<p>Dublin Cycling Campaign</p> <p>The Tailors' Hall, Back Lane, Dublin, D08 X2A3. www.dublincycling.ie RCN 20102029</p>
<p>To: An Bord Pleanála</p>	
<p>Date: 12th July 2022</p>	
<p>Re: Bus Connects Dublin - Belfield / Blackrock to City Centre: Case no. HA29N.313509</p>

DUBLIN JUNCTION MOVEMENT SEQUENCE (A)

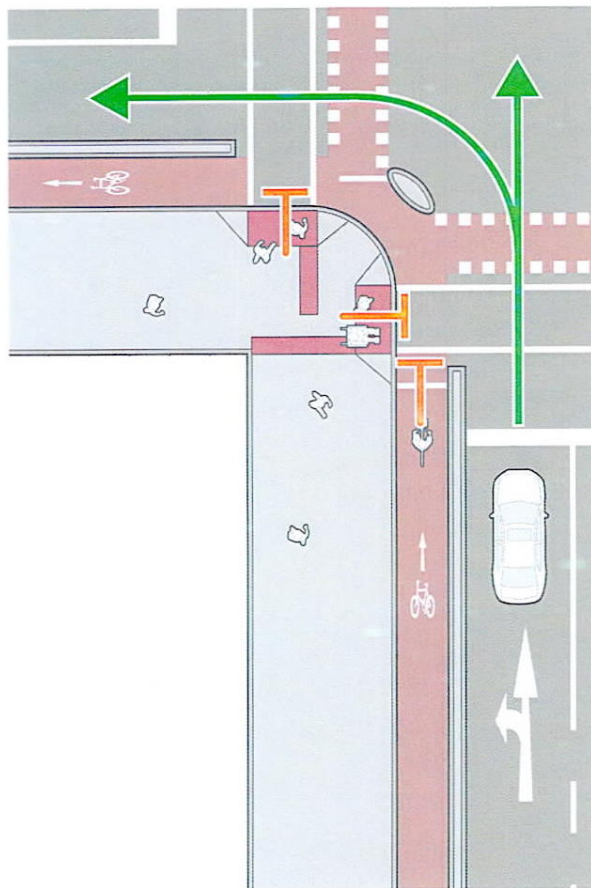
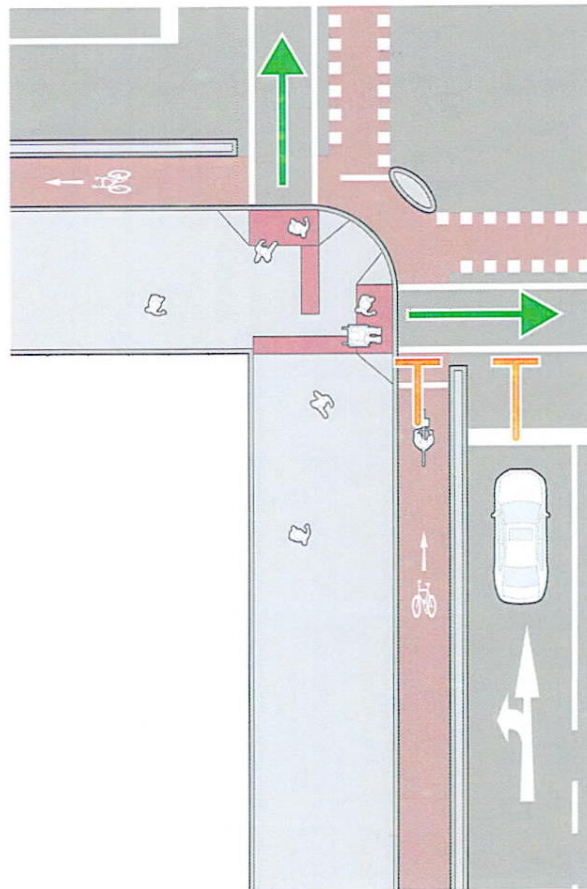
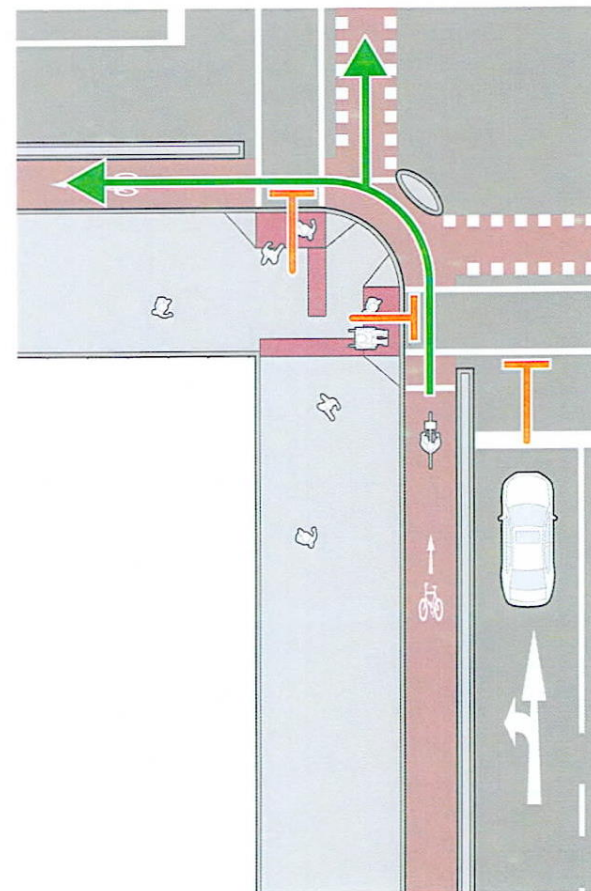
NOTE: Interrupting the cycle lane with the controlled pedestrian crossing will add an extra 5m to the pedestrian crossing span.

DUBLIN JUNCTION MOVEMENT SEQUENCE (B) (NOT SAFE FOR LARGE OR BUSY JUNCTIONS!)

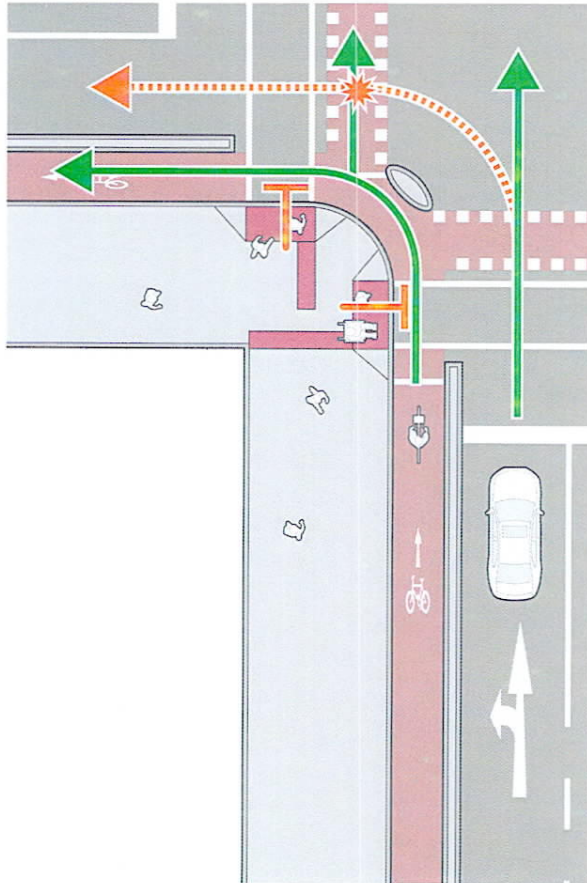
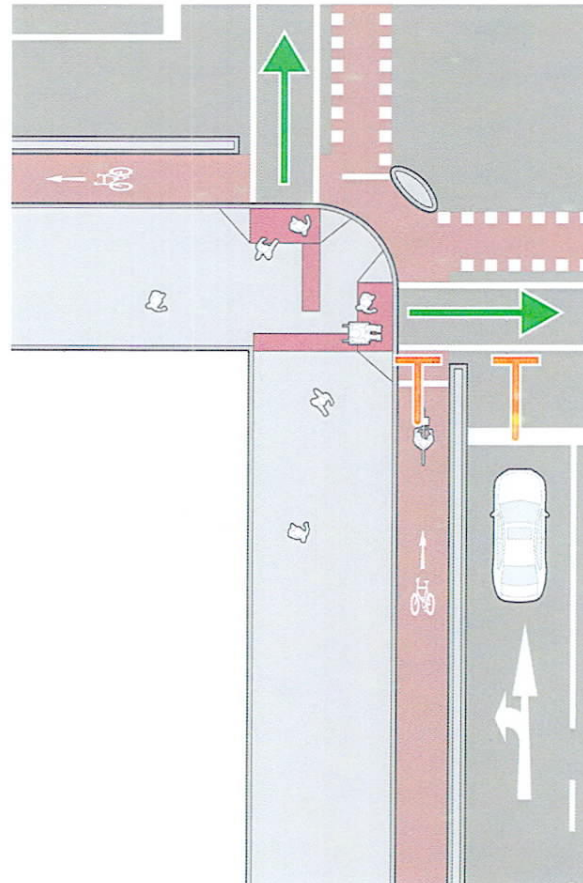
- 1** All motor & cycle traffic proceeds.
All pedestrian traffic is held.
High risk of conflict between cycle and motor traffic.
